Service Bulletin

Bulletin No: 36 001 01 (020) Revised

BMW Motorcycles

Recall 01V-198: Rear tire sidewall defect

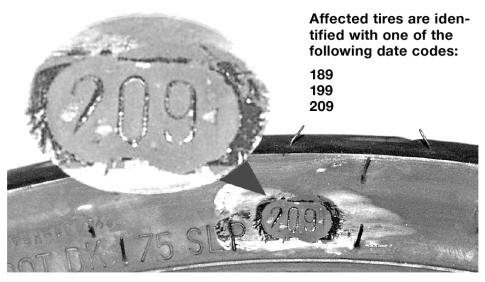
This campaign is limited to those Sportmax A rear tires having manufac-

turing date stamps of 189, 199, or 209.

Date stamps are found on the tire side

wall as shown.

> The photo below illustrates the location on the side wall and the general appearance of the manufacturing date stamp that will need to be checked on all motorcycles affected by this recall.

Service The rear tire of each affected motorcycle is to be inspected. If a tire of the Measures: affected make, model and date range of manufacture is found to be in use, it is to be replaced.
